RE: DAYTON HIGH SCHOOL – RENOVATIONS AND ADDITIONS
REH Project #168-715; KDE BG #16-114

Following is our response to your Schematic Design Review dated 4/15/16, item by item:

Kentucky Department of Education
District Facilities Branch
Division of District Support
SCHEMATIC DESIGN REVIEW

Upper Level

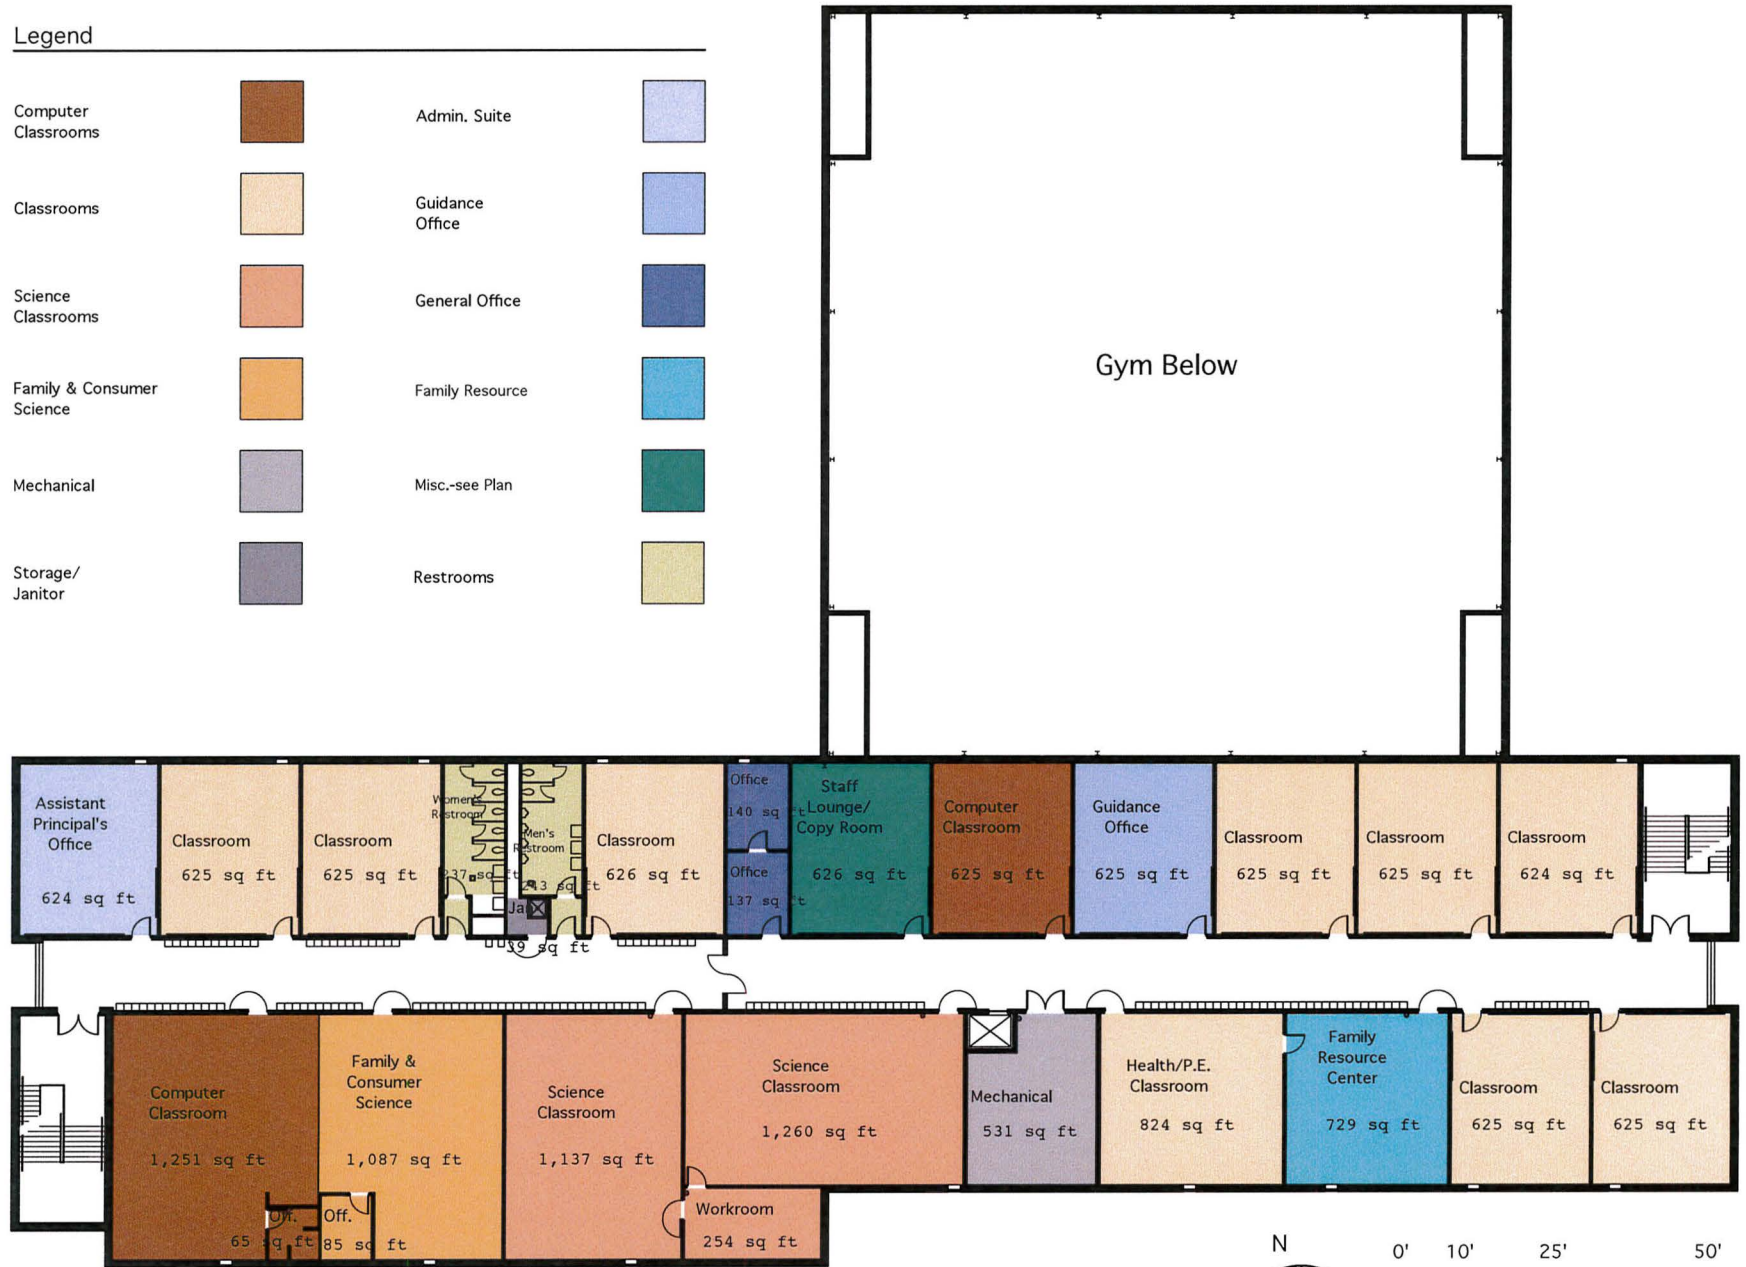
5. The Family Resource Room is on the Upper Level, as identified on the attached Upper Level Plan in the bright blue block.
6. In response to the comments regarding the First Aid Room:
